**CONTINUING ELIGIBILITY INSPECTION (CEI) REPORT FOR
FLOOD CONTROL WORKS (FEDERAL)**

1. Project Name: Namu River Flood Control Project
2. Date of Inspection: October 23, 2007
3. Inspection Personnel:

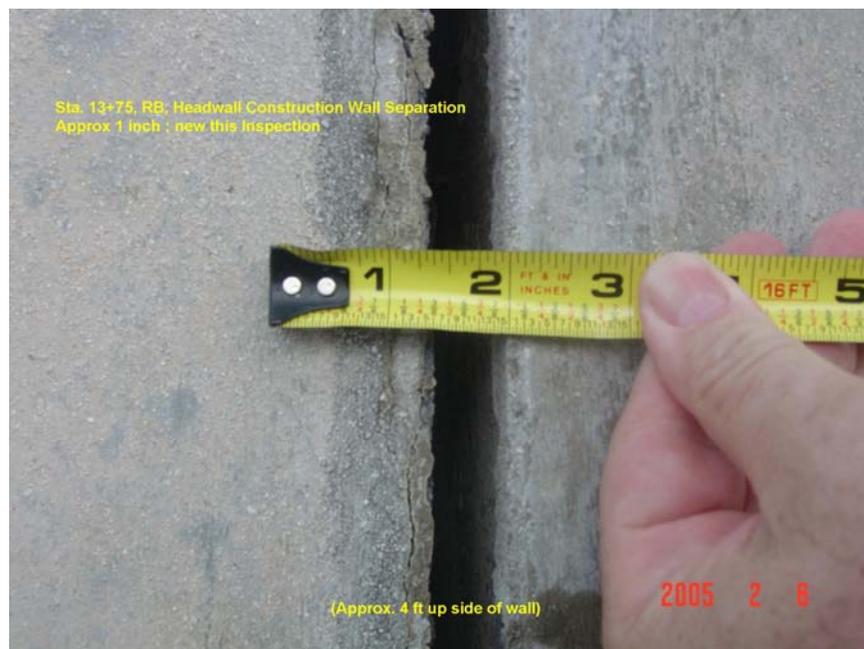
k. Sta. 13+25, Overview of Weir Structure.

l. Sta. 13+66, LB, Headwall and Invert Step, no change this year.
